PRE-CONSTRUCTION MEETING

CIP#500 C Santa Fe River (Ricardo St to Don Jose)

CIP 500 C: Santa Fe River at La Joya Street River Bank Stabilization Repair (Phase 3b)
AND Flood Damage Repair Ricardo Bridge to Don Jose Storm Drain Outfall
BID # '20/05/B
ADDENDUM NO. 2
September 18, 2019

Potential Access Points

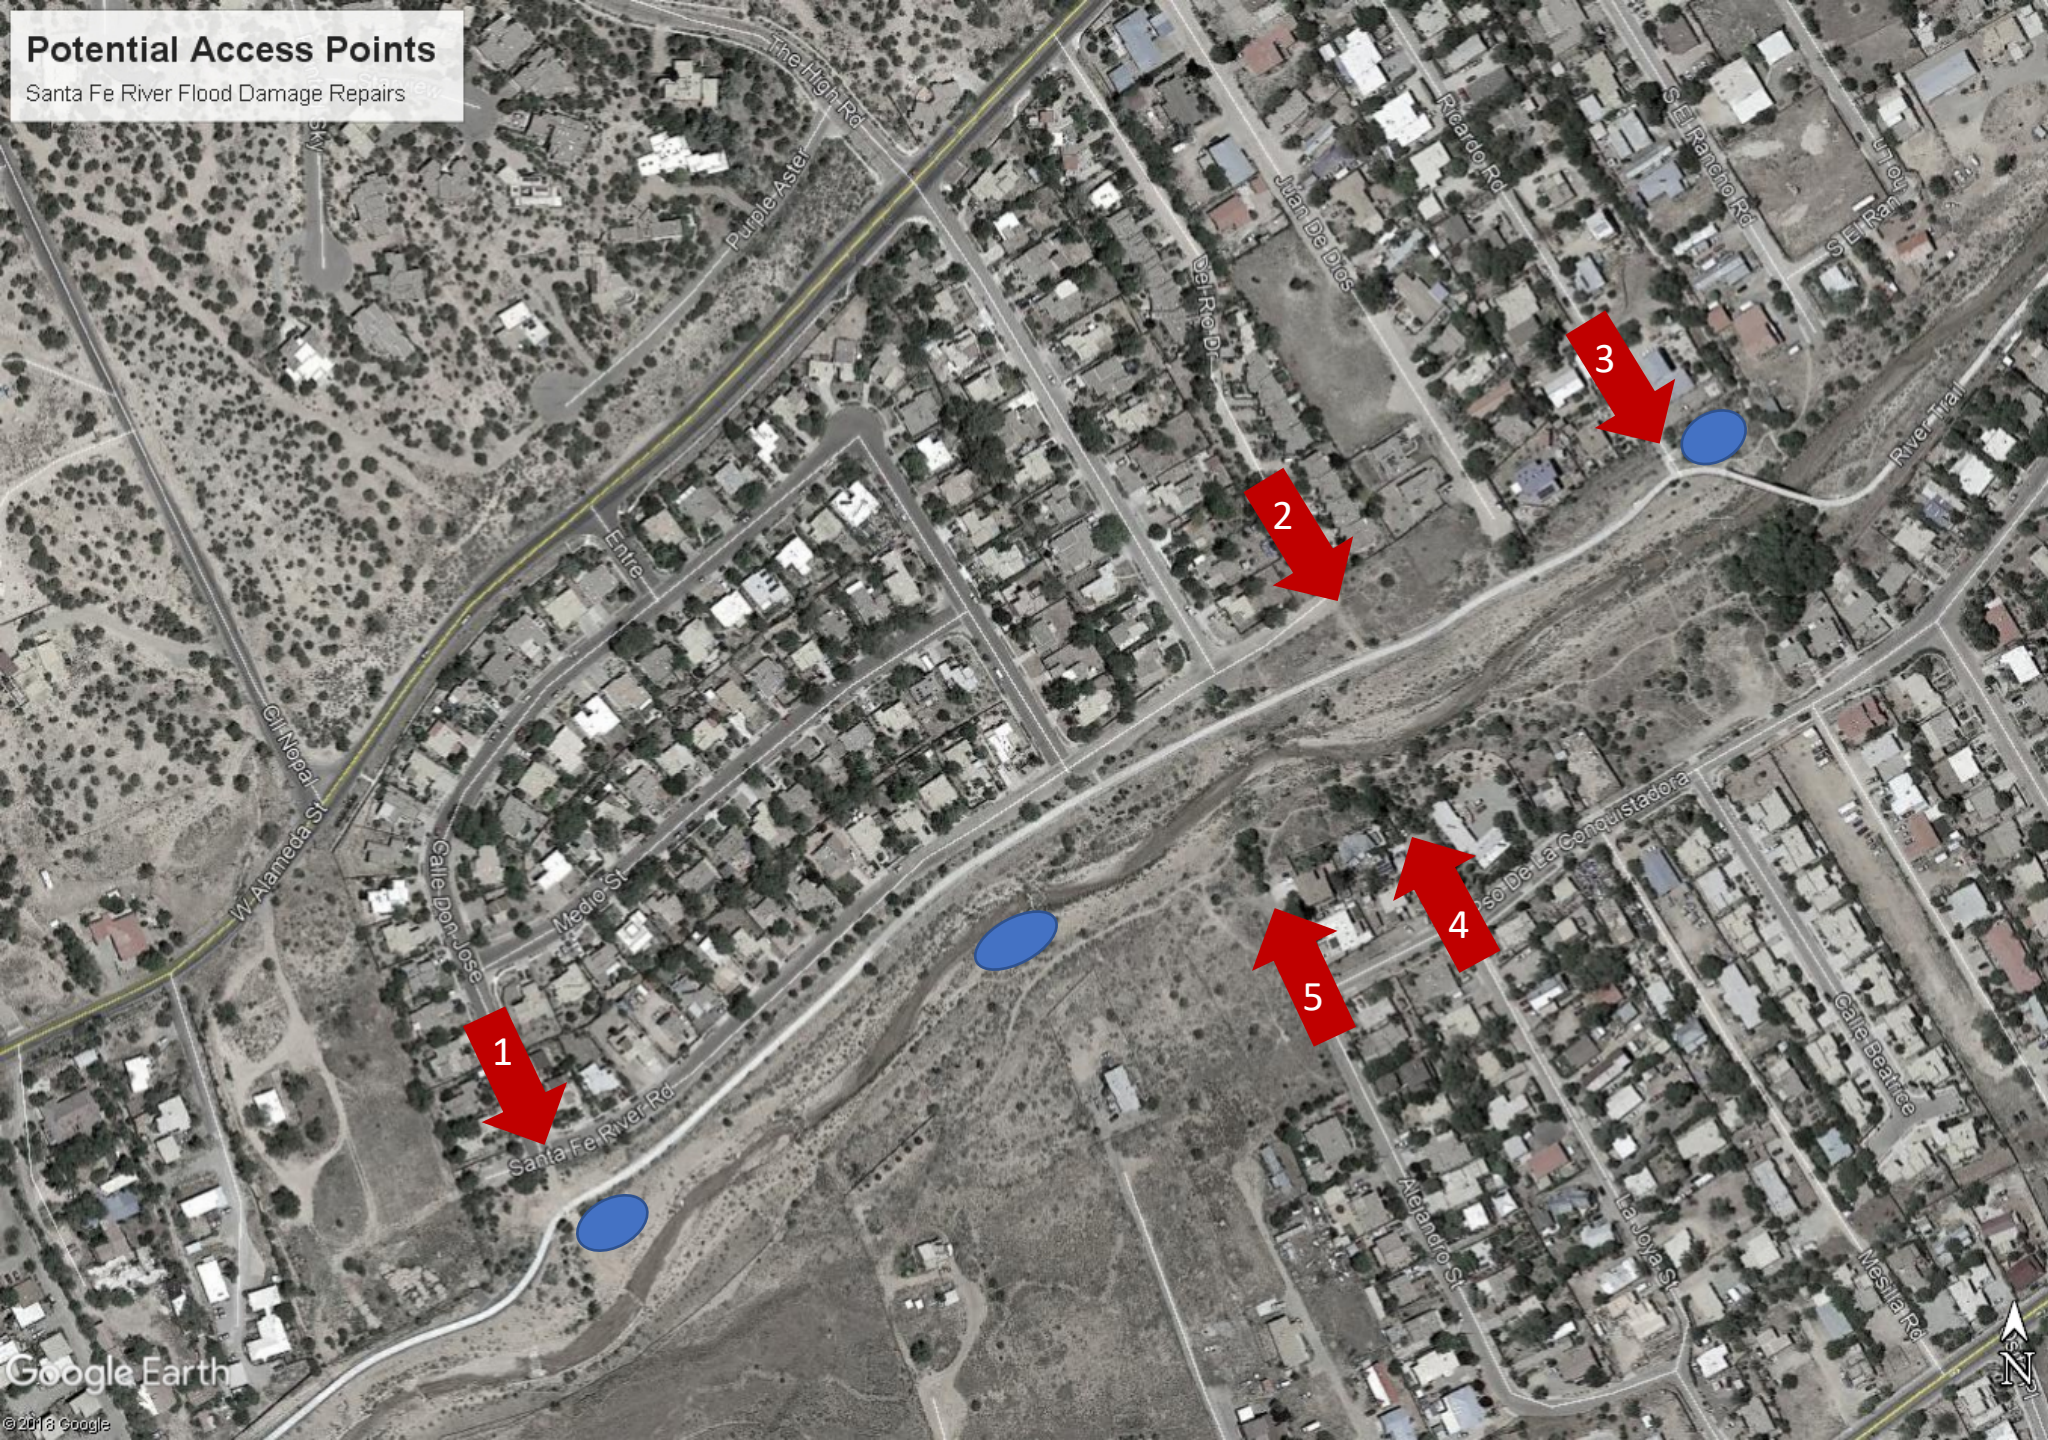
1. Preferred access at Calle Don Jose – direct access to river.
2. Del Rio Drive – would require cutting new ramp down to river.
3. Ricardo Road – Existing barricades would need to be removed. River access would be difficult.
4. La Joya Street – Access to/via rundown reconstruction site.
5. Alejandro Street - Access to/via rundown reconstruction site.

Q5: Where will temporary construction access be permitted?

The locations described above provide a number of alternative access points to the river for construction equipment. Contractor is responsible for obtaining written permission from the City and/or private landowners, as applicable. Contractor is also responsible for restoring temporary access points and staging areas to pre-construction condition upon completion of the work.

A5: Please see attached map showing potential temporary access locations, as well as potential staging areas. Note that any staging areas proposed within the river floodplain may be used only for temporary boulder storage, not equipment.
